**RE: Cactus Patch Plaza
7801 La Morada Place NW
Grading and Drainage Plan
Engineer's Stamp Date: No Date
Hydrology File: H10D034**

Based upon the information provided in your submittal received 04/25/2024, the Grading & Drainage Plan **is not** approved for Building Permit and Grading Permit. The following comments need to be addressed for approval of the above referenced project:

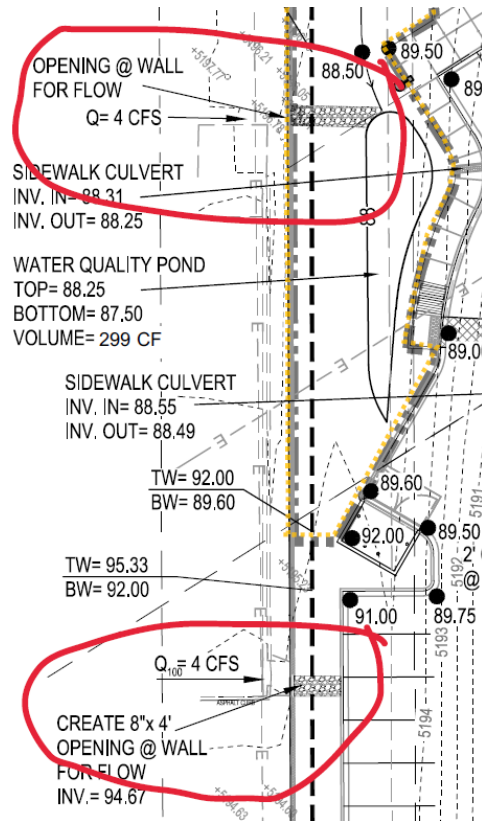
3. Please provide a curb cuts for the offsite flows (4 cfs).

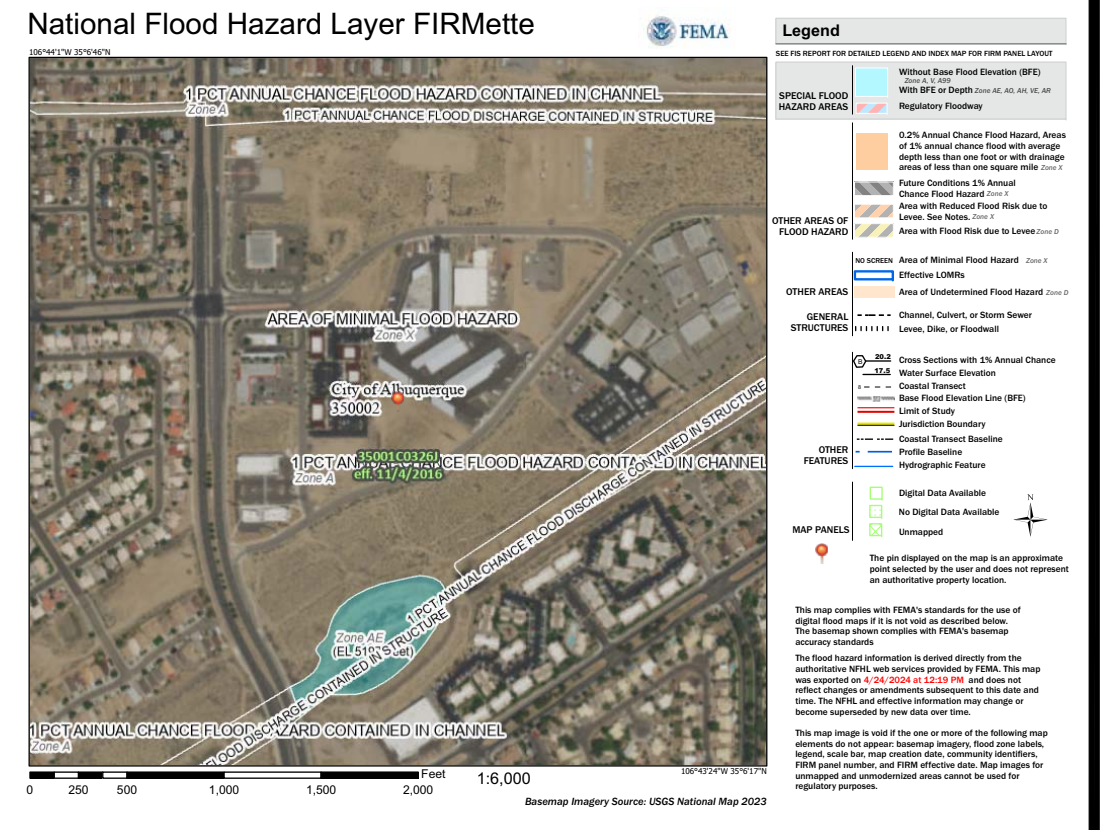
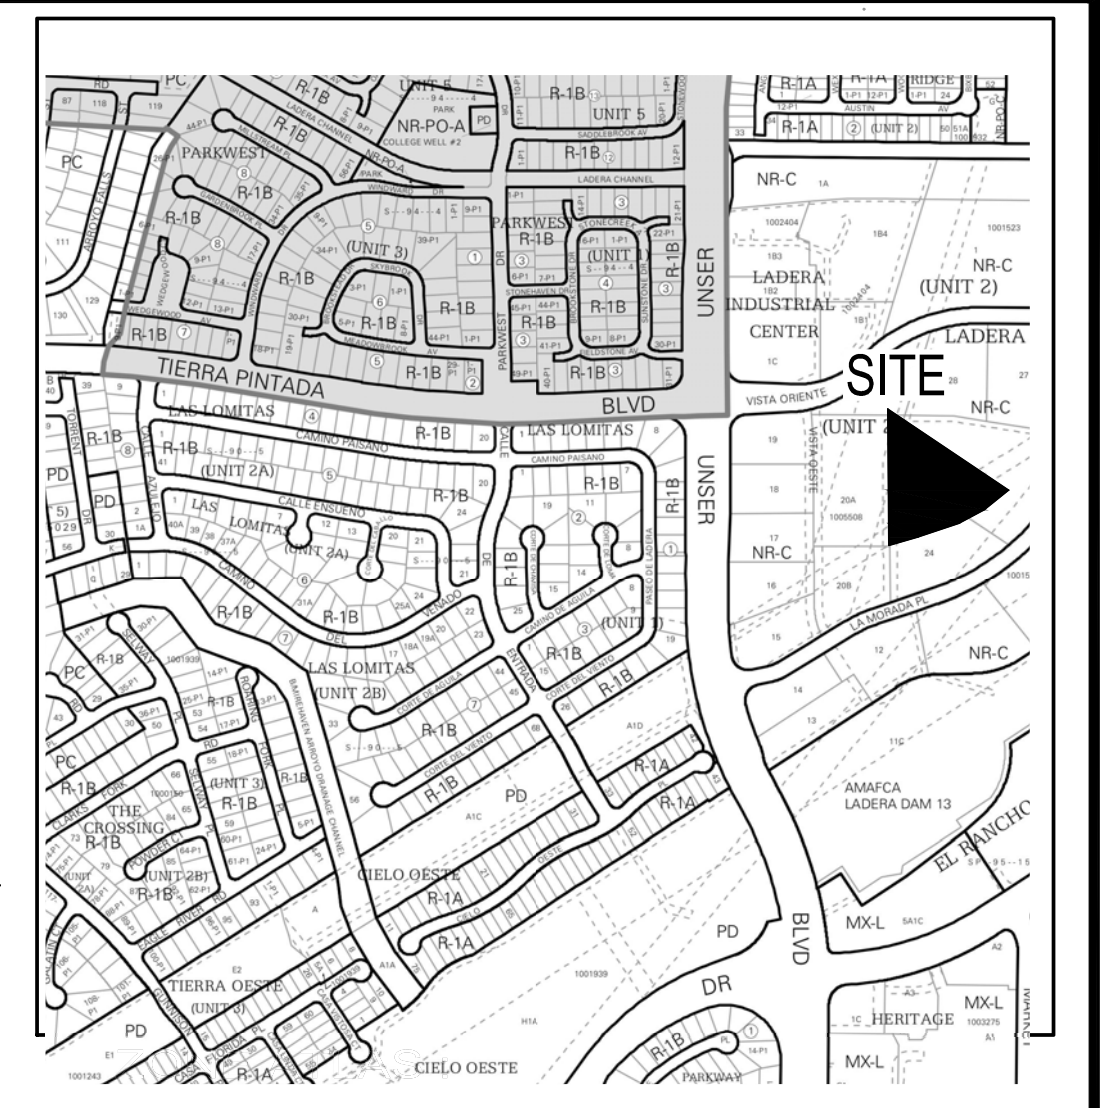
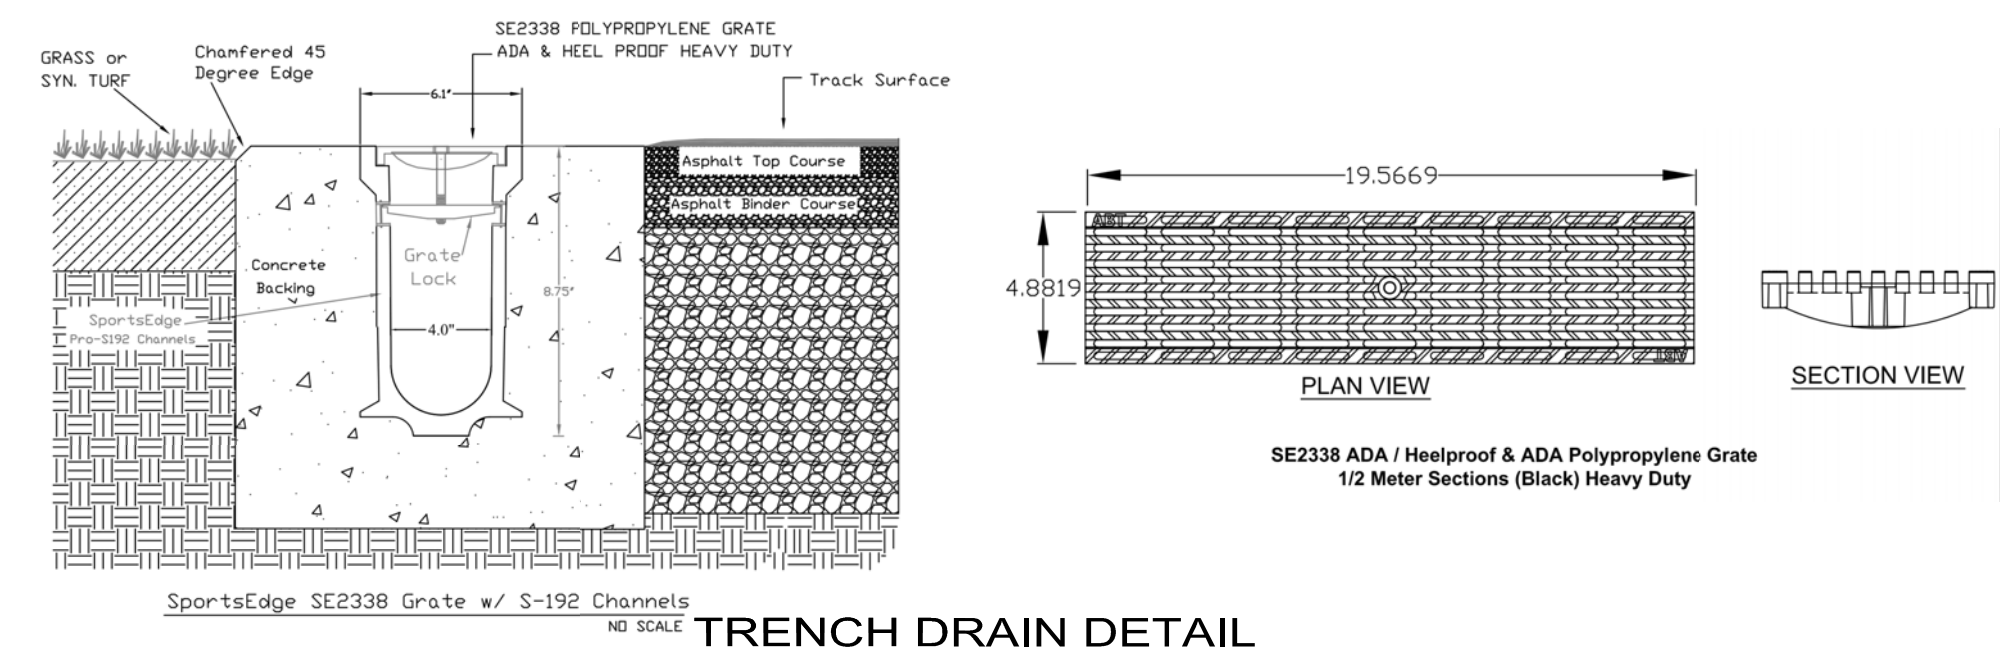
1. Please provide an engineer's stamp with a signature and date. The seal that was provided was missed sized and rotated wrong.
